Certificate of Appropriateness Case Report

HEARING DATE: MAY 2, 2018

Filing Date: March 20, 2018
Case No.: 2018-003886COA
Project Address: **Martin Luther King Jr. Drive, Golden Gate Park**
Historic Landmark: No. 210: Murphy Windmill and Millwright's Cottage
Zoning: P (Public)
OS (Open Space) Height and Bulk District
Block/Lot: 1700/001
Applicant: Dan Mauer, Project Manager, Capital Improvements Division
San Francisco Recreation and Park Department
30 Van Ness Avenue, 3rd Floor
San Francisco, CA 94102
Staff Contact: Elizabeth Gordon Jonckheer - (415) 575-8728
elizabeth.gordon-jonckheer@sfgov.org
Reviewed By: Tim Frye – (415) 575-6822
tim.frye@sfgov.org

PROPOSED GUARDRAIL SECTION & ELEVATION
3/4" = 1'-0"

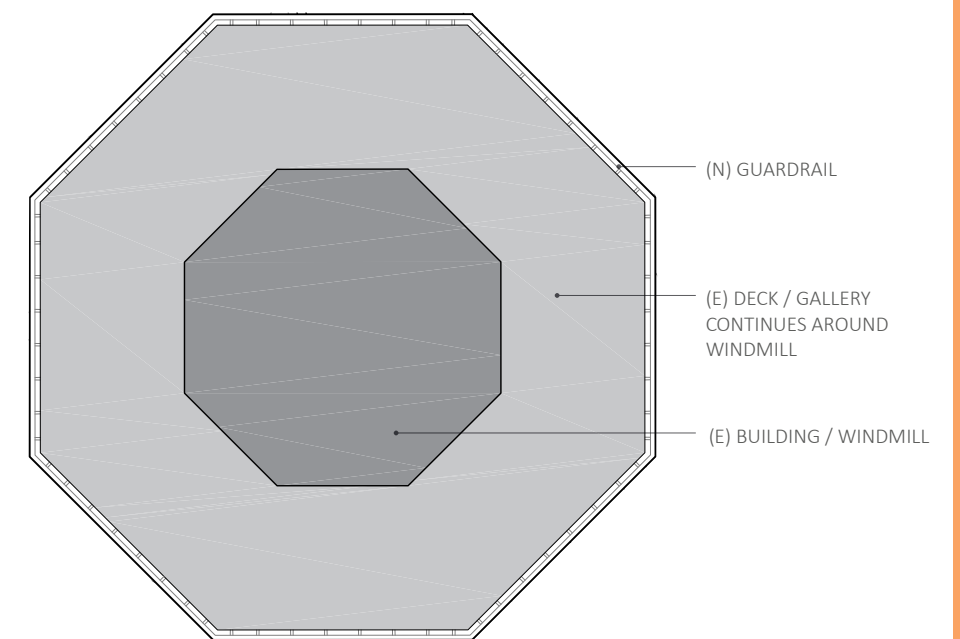
The proposed project would not alter the historic character of the Windmill. The most evident exterior alteration proposed is to the gallery railing. The new wood extenders would sit on each side of the existing vertical supports and the top cap of the railing is proposed to be in-kind wood, at the same size as existing. Overall this is a minimal visible modification to the exterior facade and the addition will not result in the loss of distinctive materials. The door replacements in-kind, the new lighting, as well as the addition of the toe-kick at the gallery, and the steel grate platform, permanent ladder, and tie-offs at the fantail, do not impact the features, spaces and spatial relationships that characterize the landmark. At the interior, the removal of the concrete water pump beds was anticipated in 2001; it is not a feature that characterizes a property. Despite the replacement of the stairs and removal of small sections of floor surface to allow for vertical, code compliant head clearance, the overall size and proportion of the stairs and landings would be consistent with the previous restoration, and would not alter the Windmill's character-defining spatial relationships at each floor level. As noted above, the proposed steel for the interior stairs and steel mesh panel are not in keeping with the character of the historic structure. This aspect of the project should be revised; the metal stairs should be replaced in wood or alternately be clad with wood, and the mesh paneling should be of a different, but compatible material.

1. *That prior to issuance of Building permits, the final material including the replacement material for the metal stairs and the mesh paneling, will be forwarded for review and approval by Planning Department Preservation Staff. As referenced previously, the interior stairs should be replaced in wood or alternately be clad with wood, and the steel mesh panel should be replaced with wood or another compatible material.*

FANTAIL

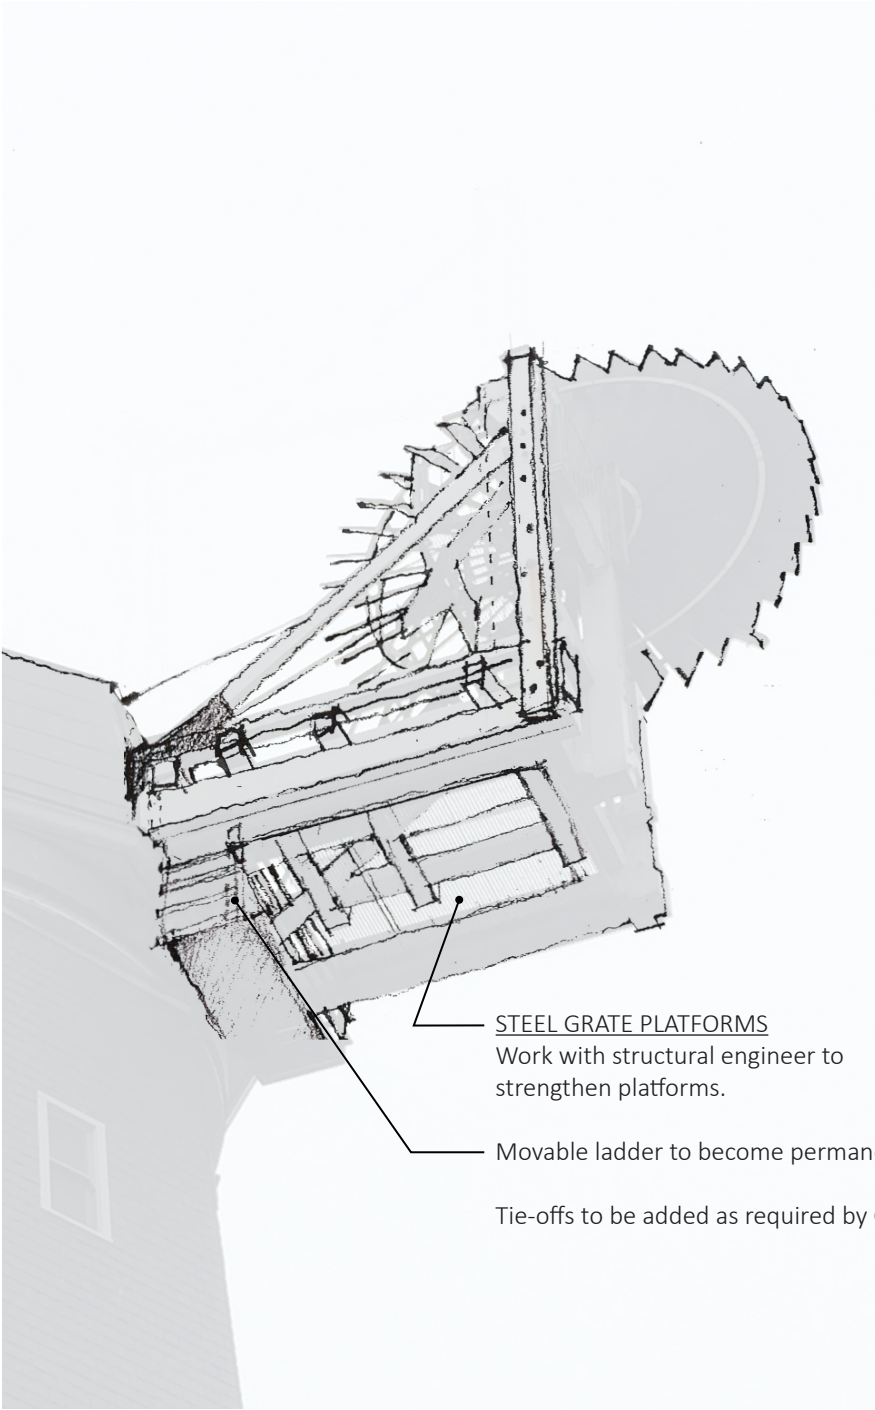
- Augment the fantail's open steel deck with additional light bracing to stiffen and reduce deflection in the steel grating surface.
- Replace the existing loose aluminum ladder with a permanently fixed ladder of the same size and appearance.
- Add tie-offs, hand holds, and cables for fall protection. Please note: in 2001 the original wooden fantail was removed and replaced as part of the restoration.

STAIR STRUCTURE CONCEPT

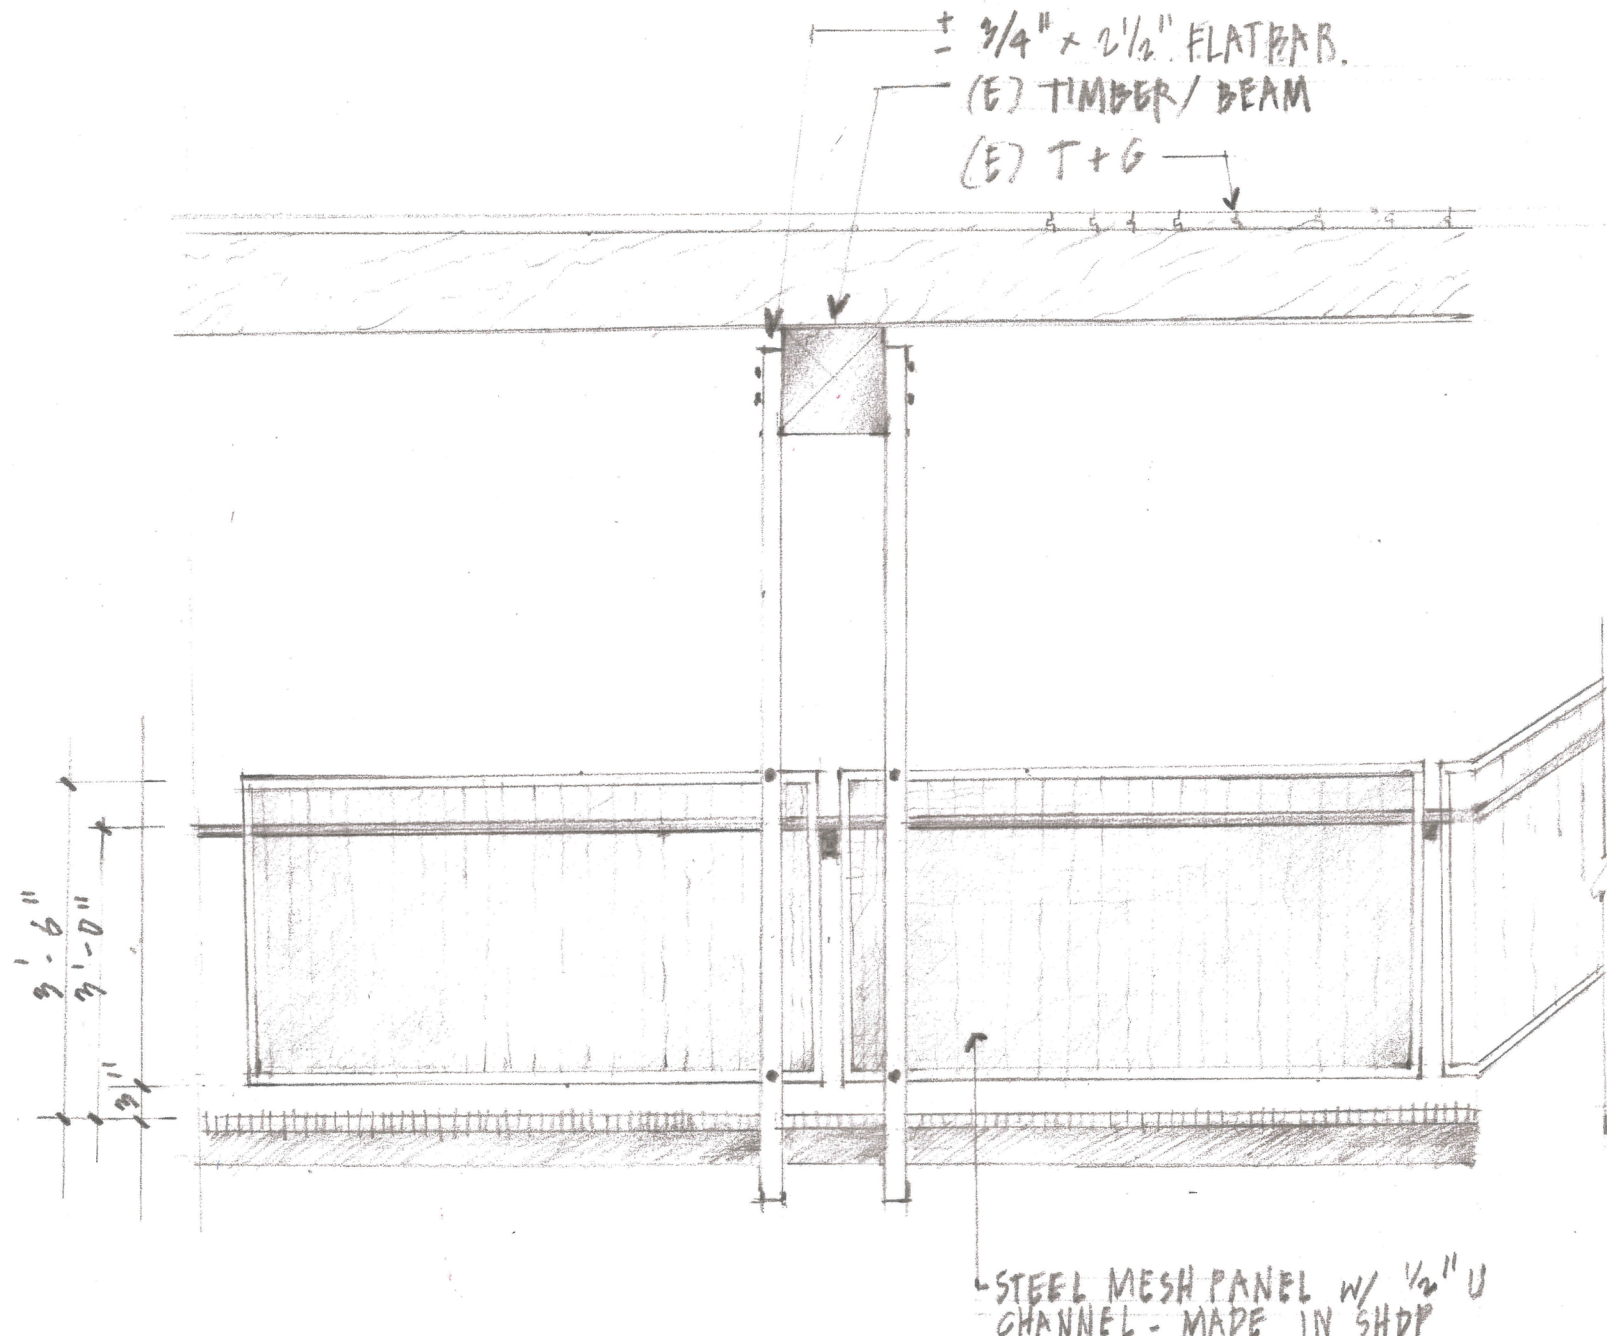
marginally visible. The wooden doors at the gallery level will be replaced in-kind. The existing interior stairs were replaced in-kind as part of the restoration project completed in 2011. Overall, the renovation of these stairs and removal of portions of the floor would not alter character-defining materials, features, finishes, and construction techniques. As noted above the steel stairs and related steel elements are not in keeping with the character of the historic structure, and this aspect of the project should be revised.

1. Specifications for replacement material for the metal stairs and the mesh paneling will be forwarded for review and approval by Planning Department Preservation Staff prior to the issuance of Building Permit Applications. The interior stairs should be replaced in wood or alternately be clad with wood, and the steel mesh panel should be replaced with wood or another compatible material.
